SEWAGE DISPOSAL SYSTEM

A REPAIR

PROPERTY OWNER Beverly Rosenberg
ADDRESS 4986 Dalton Drive

4986 DALTON DRIVE

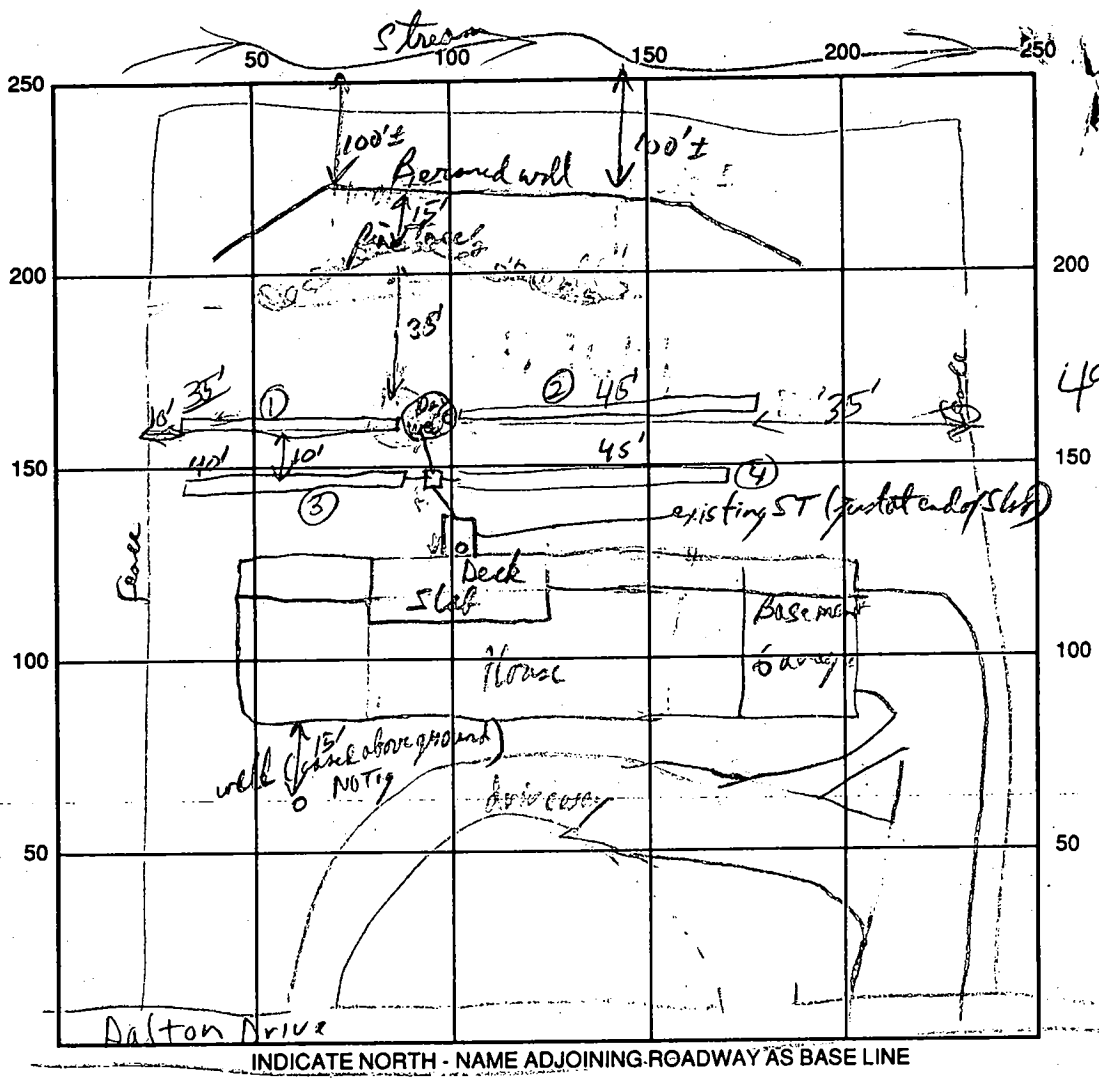
SEPTIC TANK LEVEL existing (about 750) CLEANOUTS EXIST ST. + DW.

DRAIN FIELD/TITLE DEPTH 12' FT. TRENCH WIDTH 2 FT. INLET DEPTH 8' FT.

EFFECTIVE GRAVEL DEPTH 4 FT. TOTAL LENGTH $\frac{1}{35} + \frac{2}{45} + \frac{3}{40} = \frac{4}{45}$ FT. 165'

NUMBER OF TRENCHES 4 ONE SIDEWALL/BOTTOM AREA 660 SQ. FT.

REMARKS: EXIST Sestic Tank Opened (only 8' long by 36" wide = approx 750 gal. vol) but baffle is solid + functional (just slogged in whether or not). OK to cover lot 3 trenches when finished call For less trench inspection 3/11/97. 3/12/97 4TH TRENCH COMPLETE, CONTRACTOR REPORTED OK TO COVER WHEN COMPLETE. PER CU
